Memo

Re: PUCO Case No. 17-2373-RR-FED- In the Matter of a Request for the Installation of Active Warning Devices and Crossing Surface at the RJ Corman Railroad Crossing, Staeger Road/CR 145 DOT#477-009F in Mercer County, Ohio.

TO: Randall Schumacher, Supervisor, Rail Division, PUCO
FROM: Cathy Stout, Manager, Safety Section, ORDC
BY: Greg Gronbach, Project Manager, Safety Section, ORDC
SUBJECT: Mercer County, Staeger Rd, CR145, DOT # 477009F, PID # 104282
DATE: October 25, 2017

RE: Mercer County, Staeger Rd, CR145, DOT # 477009F, PID # 104282

Diagnostic Team Recommendations

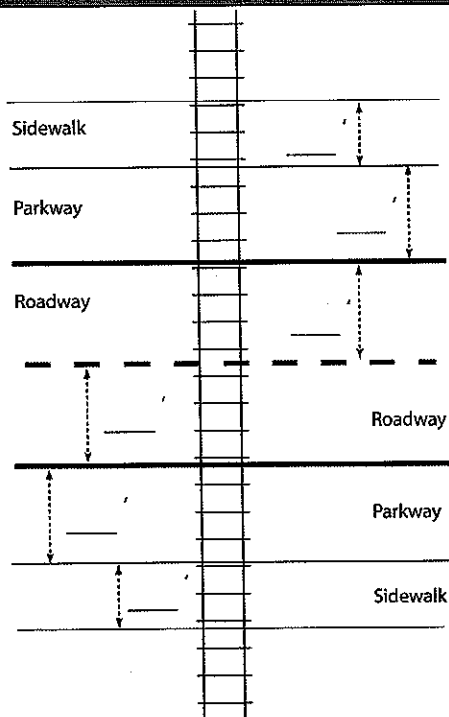
☒ Other (define) **SURFACE NEEDS REPLACED WITH LIGHT + GATES
INSTALL. (CURRENT CONDITION IS POOR)**

Field Sketch

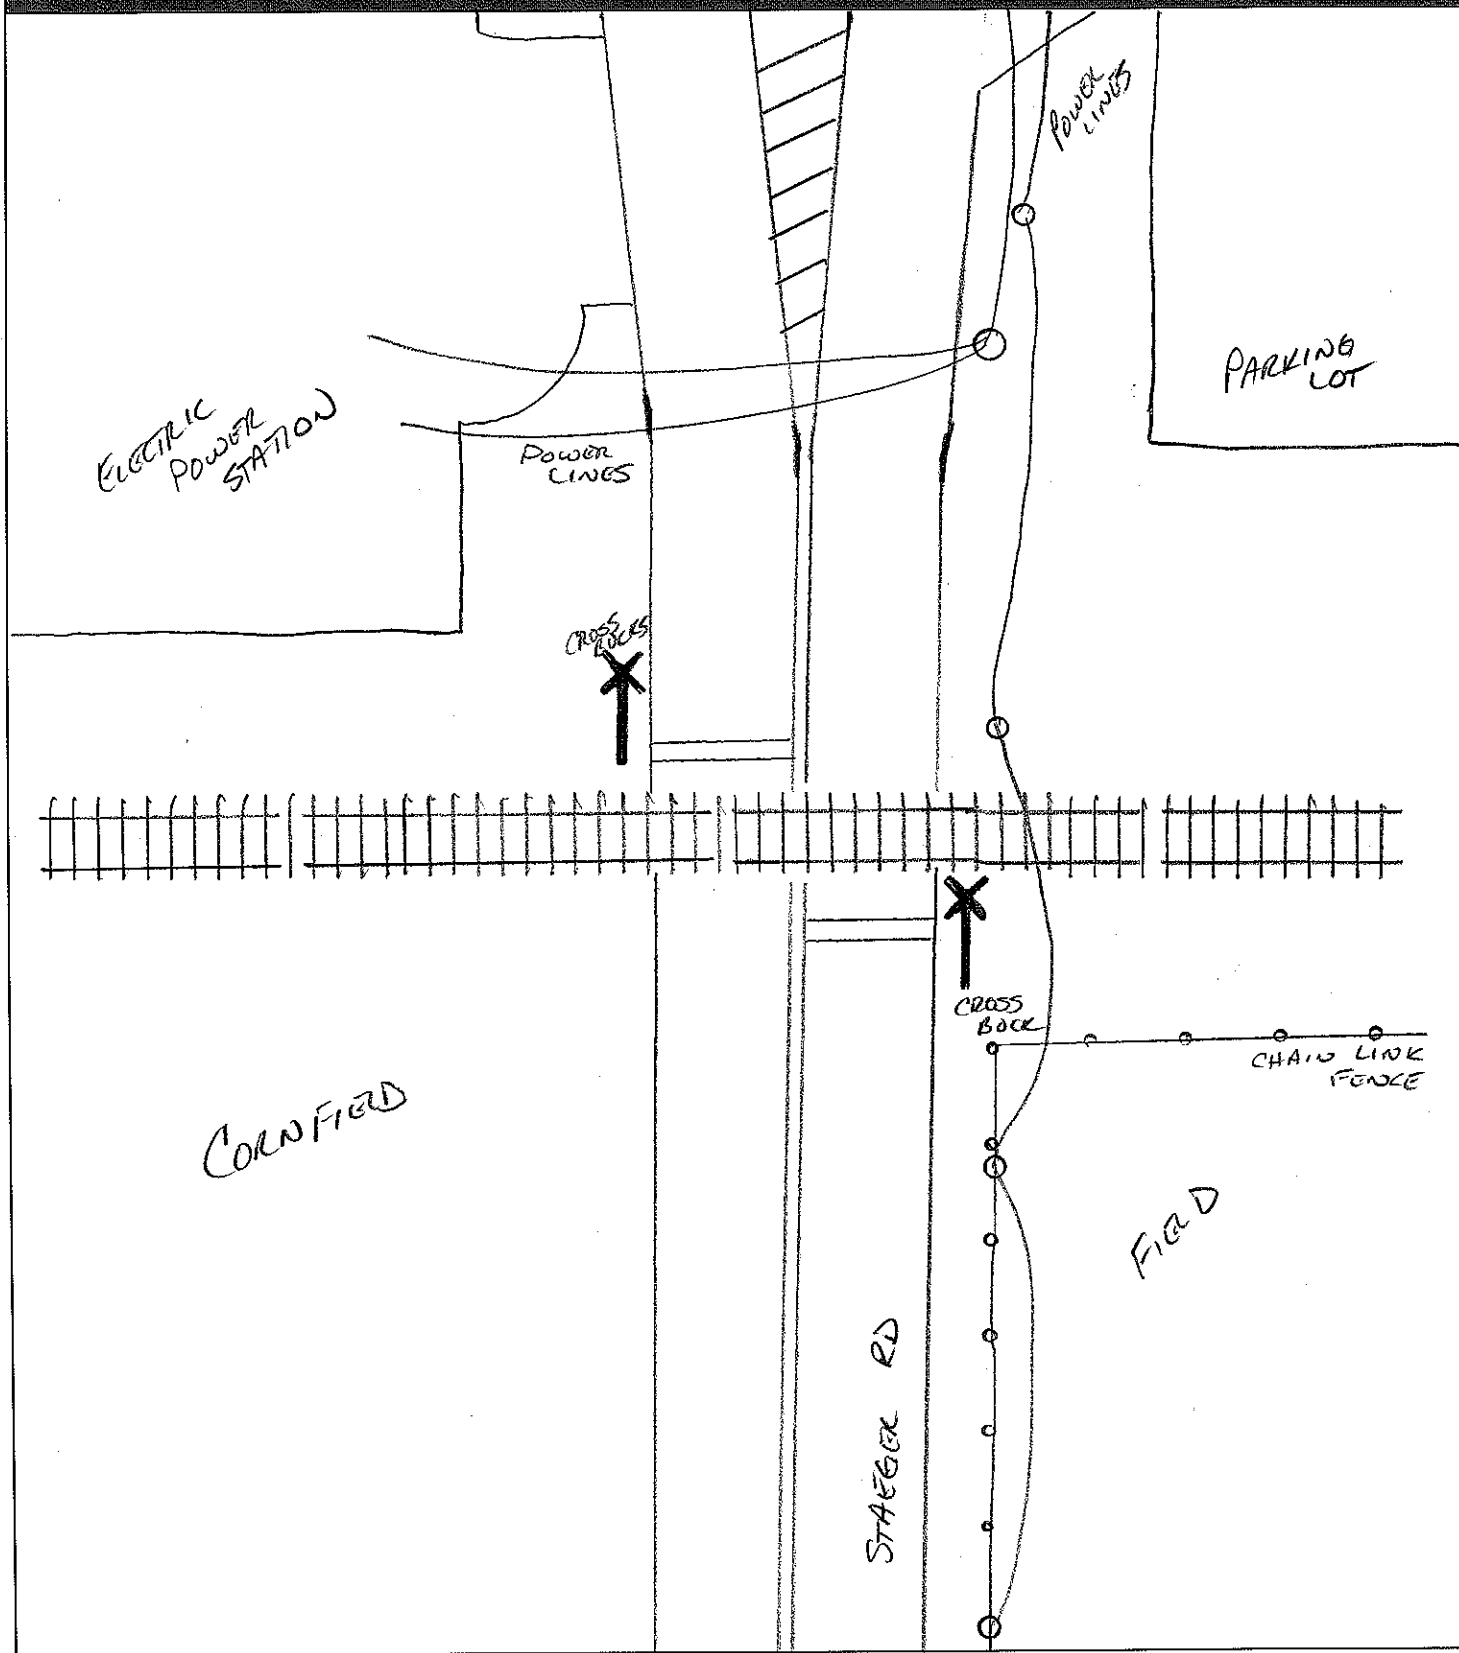
Surface type <input type="checkbox"/> Rubber seal and asphalt <input checked="" type="checkbox"/> Timber and asphalt <input type="checkbox"/> Asphalt <input type="checkbox"/> Composite <input type="checkbox"/> Concrete panel <input type="checkbox"/> Full-depth timber <input type="checkbox"/> Full-depth rubber <input type="checkbox"/> Other _____	Condition <input type="checkbox"/> Good <input type="checkbox"/> Fair <input checked="" type="checkbox"/> Poor Comments: <u>MULTIPLE HOLES,</u> <u>TRAFFIC SLOWS TO CROSS</u>
Is the surface good and sufficient? Yes / <u>(NO)</u>	
Vehicle type (cars, trucks, etc.): <u>CARS/TRUCKS</u>	
Surface conditions: Can vehicles cross at posted speed? <u>YES</u> Local observations/driver behaviors: <u>TRAFFIC SPEED IS ALOT</u> <u>HIGHER THAN 35MPH POSTED SPEED LIMIT.</u> Relevant crash history: <u>1/2016</u>	
Do existing surface conditions have negative effects on the current or proposed warning devices? Explain: <u>RR BELIEVES SURFACE WILL NEED TO BE</u> <u>APPLACED, DUE TO JOINTS BEING SO CLOSE TO</u> <u>SURFACE.</u>
